Subject: BAR Action- 512-514, 600 West Main Street - March 21, 2017

**RE: Certificate of Appropriateness Application**

BAR 16-01-04
512-514, 600 West Main Street
Tax Parcel 290007000, 290006000, and 290008000
Heirloom West Main Development LLC, Owner/Heirloom West Main Development LLC, Applicant Façade revisions

Subject: 510 - 600 West Main Street: BAR approval of exterior revisions

SOUTH ELEVATION - REVISED DESIGN

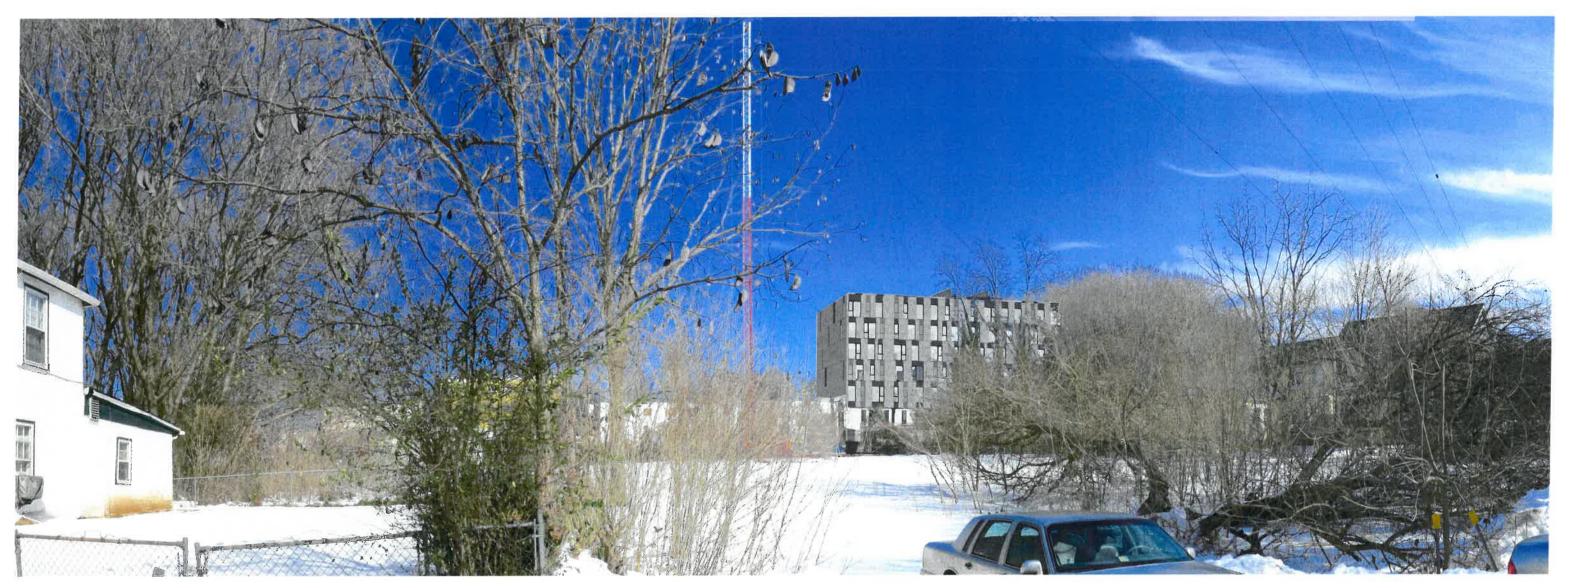
- we propose replacing most of the metal panels on the south facade with fiber cement panels, while maintaining the approved window and perforated screen overlay pattern. Metal panels of the east and west facades wrap the corners and bookend the edges of the south facade. The fiber cement panels will have reveals at their vertical joints so the pattern of the fiber cement panels will be emphasized and will remain consistent with the patterns on the other facades.
- in lieu of a zinc finish on the metal panels, we will be proposing a painted finish that closely approximates the color of the zinc.

- The south facade of the building will be revised to include more fiber cement panel and less vertical metal siding. In order to maintain consistency with the other building facades the windows will still have a shifting pattern from floor to floor, as will the joints of the fiber cement panels. We will also keep vertical panels of perforated metal in front of some of the windows.
- The zinc material will be substituted with painted aluminum panels, with a color similar to the zinc. The patterning of the facade will remain as approved. We will bring aluminum samples to the meeting on 03.21.2017 for review.

Balut moved to find that the proposed material changes satisfy the BAR's criteria and are compatible with this property and other properties in the West Main Street ADC District, and that the BAR approves the changes as submitted. To be clear we are approving the substitution of zinc panels on all facades with the painted aluminum panel (the color and texture to be determined) and on the south façade we are also approving the substitution of the zinc metal panels with the light grey Hardie panel as presented tonight. Gastinger seconded. The motion passed (6-1, with Schwarz opposed.)

SOUTH ELEVATION - REVISED DESIGN

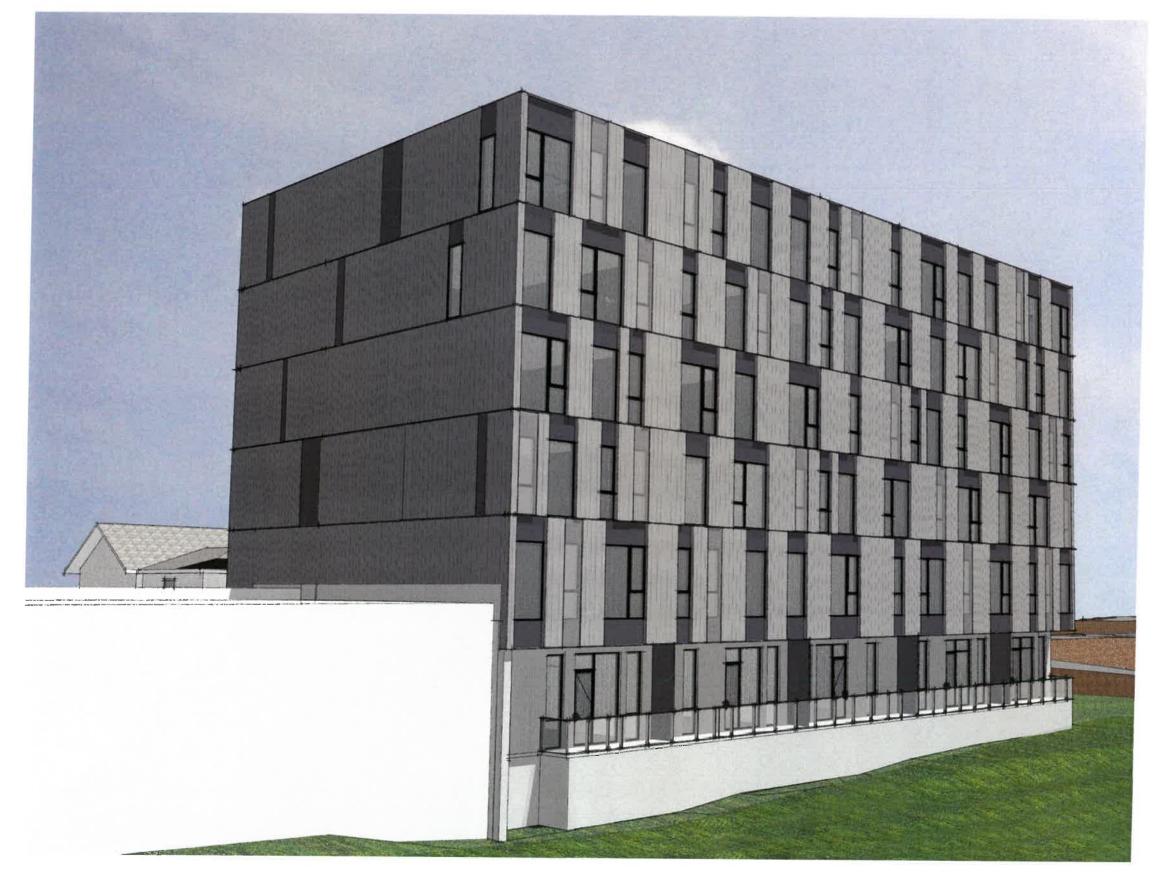
Previous approval
SOUTH ELEVATION

not approved SOUTH ELEVATION - REVISED DESIGN

1.4R

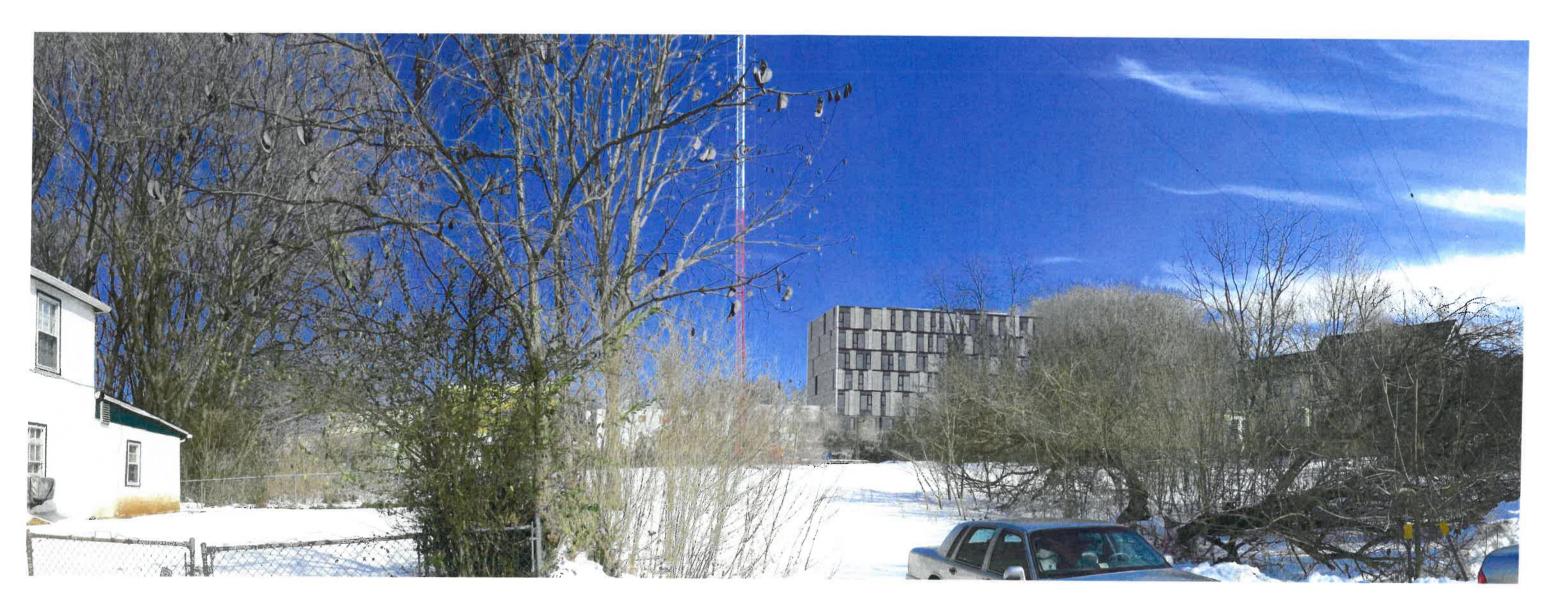
previous version 2/28/2017

not approved 2/28/2017

3/21/2017 approved version
